SERVICE BULLETIN

Service Bulletin #: SB07

Title: Software Support for SR20 Version 2.0
and Correction of Engine Configuration

Figure 1: MFD with Compact Flash Cover Removed

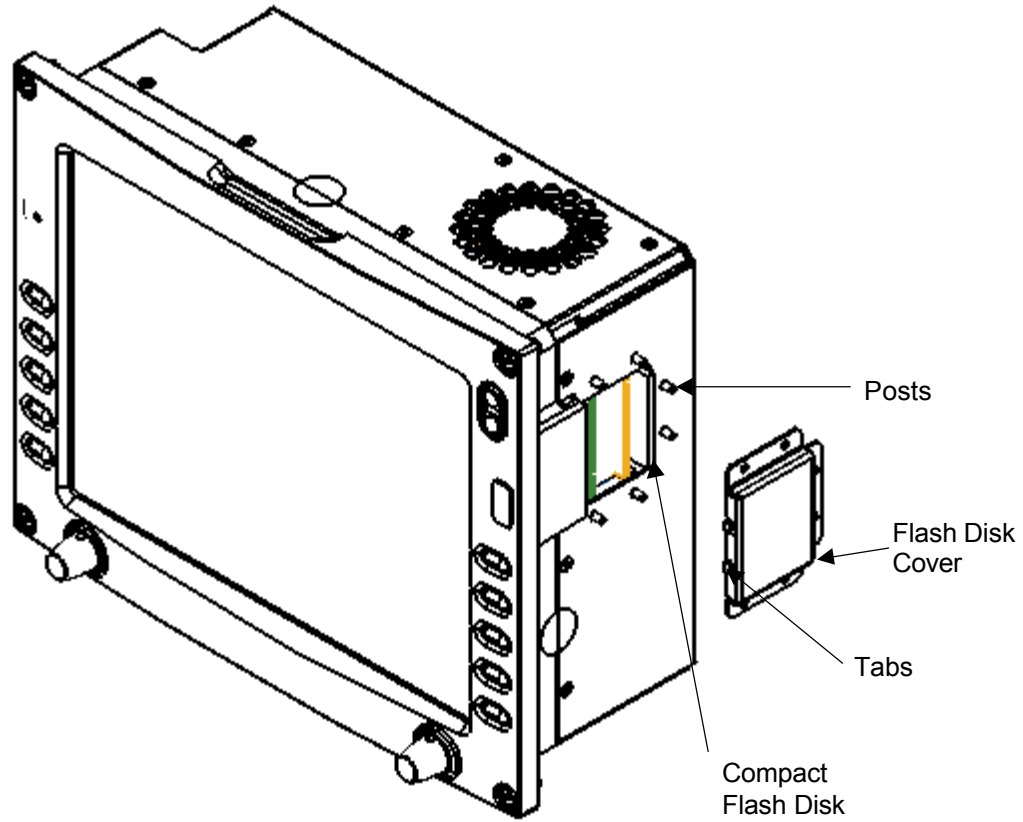
This procedure should be performed on the bench. Ensure NO power is applied to the unit. Refer to Figure 1.

1. Remove the Flash cover by unscrewing the 6 nuts and lifting the cover off the posts.
2. Remove the compact flash (See Effectivity/Compatibility) by pulling it from the connector and sliding it out (as shown in Figure 1).
3. Record
